Access Compliance Report

Public Rights-of-Way

(Curb Ramps)

Intersection ID: 12779	Main Street: E_TRADE_ST	Cross Street: S_DAVIDSON_ST	Location: S
ADA ID: F6A5F0052042	Ramp Type: Perp	Initial Pass/Fail: Pass	Overall Compliance: No
Severity Score: 5			
Codes/Mitigation Info/Possible Solution		Field Measurements/Component Compliance

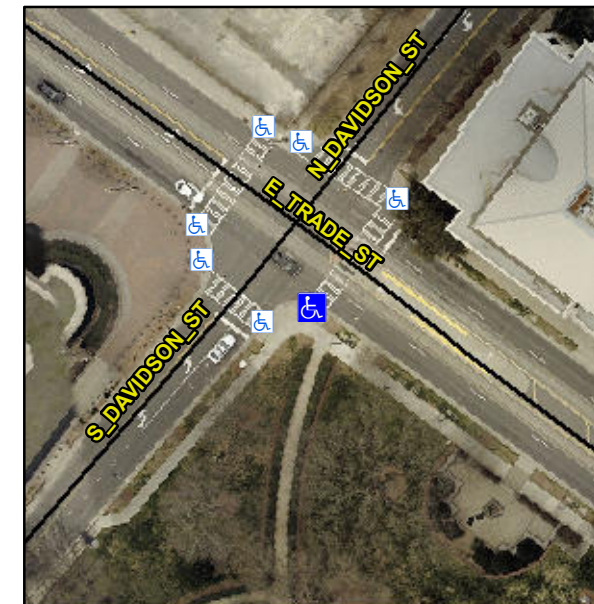
Not Found, R304.2.1, R304.5.4

Compliance	Description	Data	Compliance	Description	Data
N/A	Ramp Length (in)	84.0	Yes	Ramp Slope (%)	8.1
Yes	Ramp Width (in)	48.0	Yes	Ramp XSlope (%)	0.4
N/A	Flare Type LT	Sloped	N/A	Flare Type RT	N/A
N/A	Flare Slope LT (%)	4.3	Yes	Flare Slope RT (%)	8.8
N/A	Flare Traversable LT?	No	N/A	Flare Traversable RT?	Yes
Yes	Landing Length (in)	93.0	Yes	DWS Provided?	Yes
No	Landing Width (in)	47.0	Yes	DWS Contrast?	Yes
Yes	Landing Slope (%)	1.6	Yes	DWS Length (in)	25.0
Yes	Landing X Slope (%)	0.9	Yes	DWS Full Width?	Yes
N/A	Landing Curb? (Y/N)	No	Yes	DWS Offset (in)	1.5
N/A	Shared Landing?	No			
Yes	Gutter Ponding?	No	No	Gutter Slope (%)	6.4
Yes	Gutter Lip Ht (in)	0.0	Yes	Gutter X Slope (%)	1.8
N/A	Painted X Walk1?	Yes	N/A	Painted X Walk2?	N/A
	X Walk 1 Direction	To NE		X Walk 2 Direction	N/A
N/A	X Walk 1 Width (in)	110.0	N/A	X Walk 2 Width (in)	N/A
	X Walk 1 Slope (%)	1.6		X Walk 2 Slope (%)	N/A
	X Walk 1 X Slope (%)	0.6		X Walk 2 X Slope (%)	N/A

Yes	Ramp inside XWalk1?	Yes	N/A	Ramp inside XWalk2?	N/A
	Road Slope (%)	N/A	N/A	Clear Space?	Yes
	Road X Slope (%)	N/A	N/A	Clear Space to XWalk (in)	N/A
Yes	Any Obstructions?	No	Yes	Storm Grate/Utility Hazard?	No
	Obstruction Type			Storm Grate/Utility Type	
		N/A			N/A
			Yes	Surface Condition? (G/P)	Good

**Remove & Replace Entire Ramp.
Remove & Replace Gutter.**
